line to 2nd lake  
dredge for  
mining

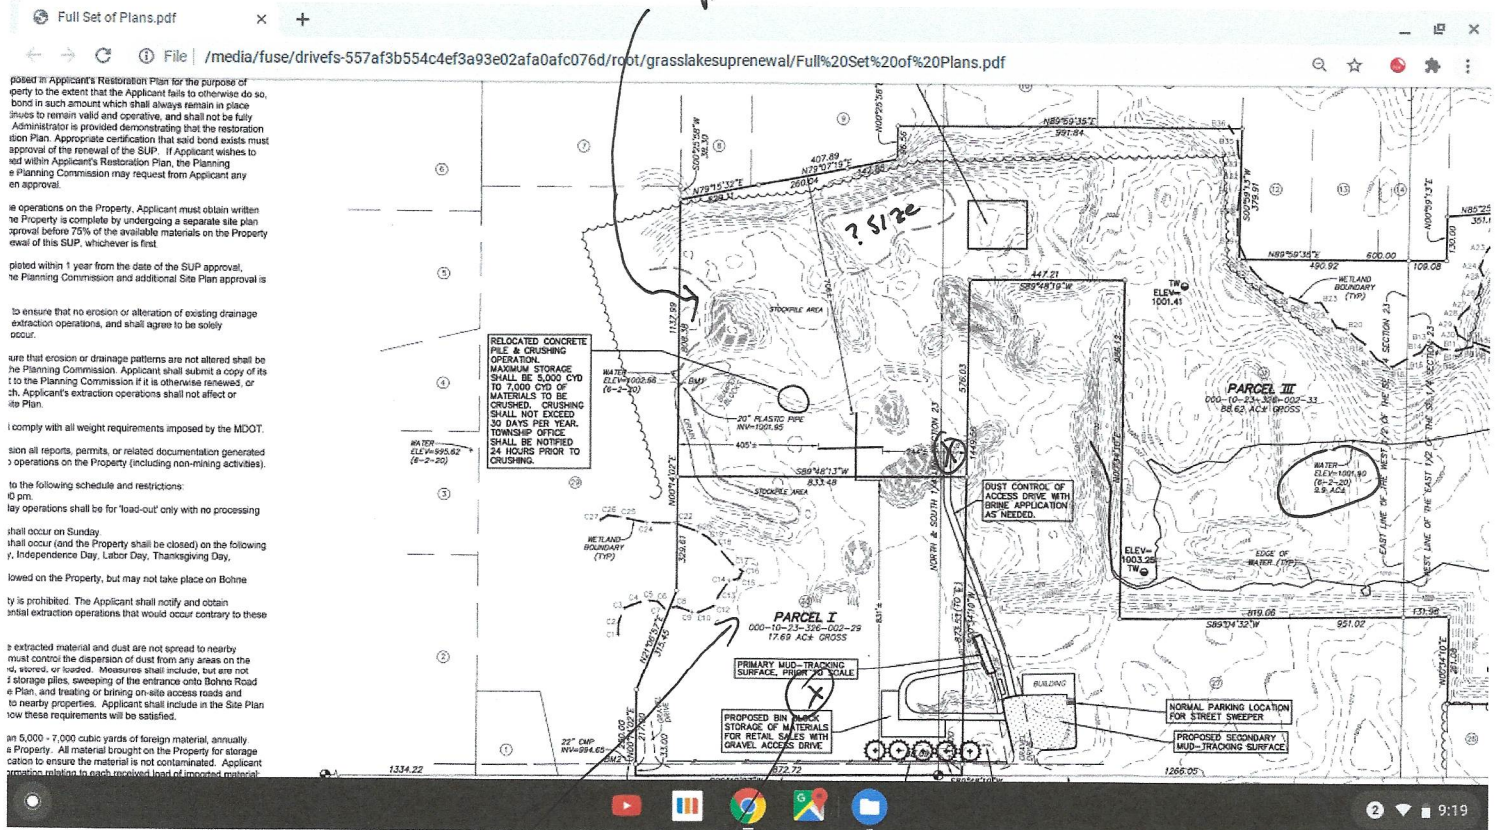
2nd  
lake

line from  
dredge

outlet  
for dredged (mined)  
material

Small lake MISSING

? size

destroyed wetlands

MISSING remains of wetlands

- use need contours for post mining
- End Use
  - residential
  - high water
  - no land available
  - need to submit plan
  - Agricultural
  - where - mostly water
  - shallow ~~ground~~ gw
  - no vadose zone
  - fertilizer 1/1
